REVISION TO AIRCRAFT PUBLICATION: EC 155 B1

PUBLICATION CONCERNED: FLIGHT MANUAL

Regulatory Part RN 22 Date code 23-06 Certification code A SUP.62 RN 2 Date code 23-06 Certification code A

Issue dated: June 05, 2023

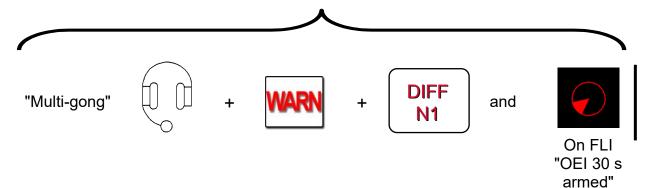
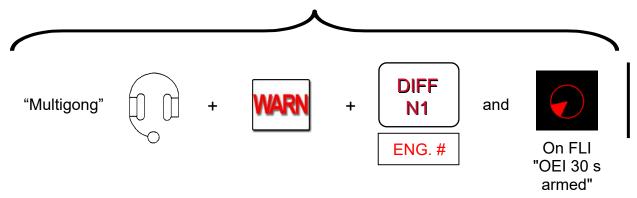
3.3	5	- "ALARM" warning light is corrected by "WARN" warning light in both procedures.
3.3	7	- Correction: "EMERG" is replaced by "EMER" Addition of L/G operating light pictures.

Figure 1: Exterior Inspection

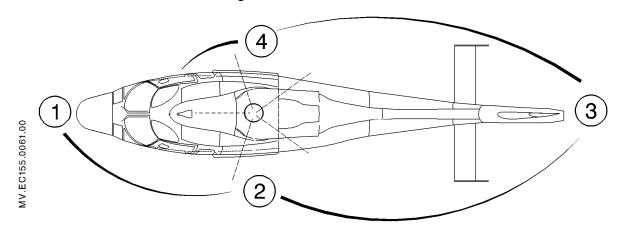
4.2	1	- Addition of Fuel tank purge procedure before First Flight of the Day.
4.2	2	- Wording improvement. Data remain unchanged.
4.3	1	- Wording improvement. Data remain unchanged.

- Purge fuel tanks before moving the aircraft.
 This task can be done whether by a mechanic or by a pilot who received sufficient training.
- Check that the bleeders are closed once the purge is done.

Figure 1: Dual GTN 750H GNSS RNAV system simplified diagram

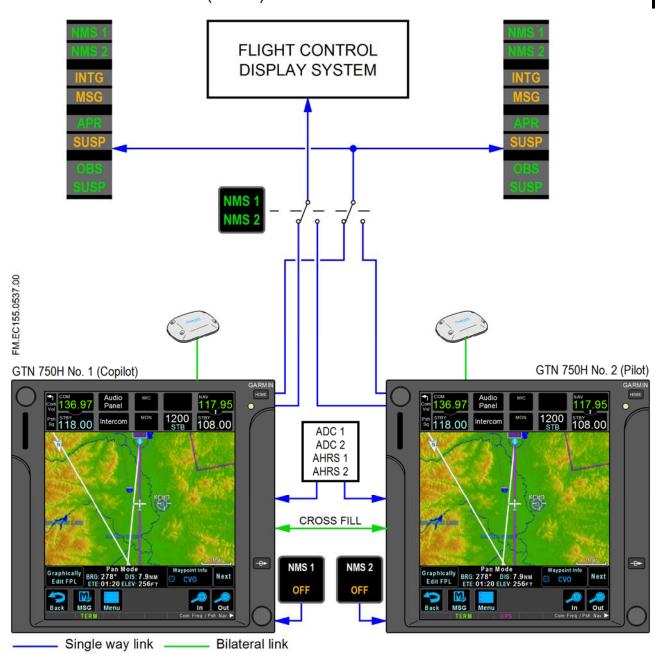
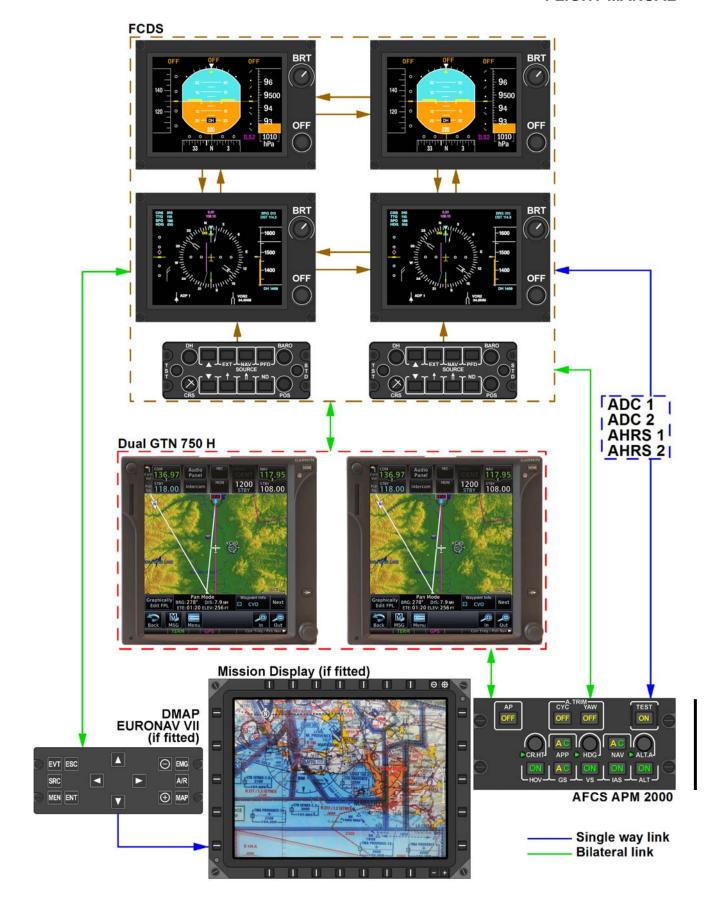
4.3	8	- Spelling correction Pictures improvement.
4.3	9 to 11	- Pictures improvement.
4.4	2	- "MTOP" is replaced by "TOP".
5.0.P6	1	- Update of page numbers.
SUP.62	2	RN2 23-06
SUP.62.P5	1 to 2	- Update of the List of approved effective pages and Log of normal approved revisions.
SUP.62	2	- "B1" (RNAV 5 GNSS) and "C1" (RNAV 2 GNSS) indicators are corrected by "B2" and "C2".
SUP.62	5 and 6	- The AFCS APM 2000 picture is corrected in both diagrams.
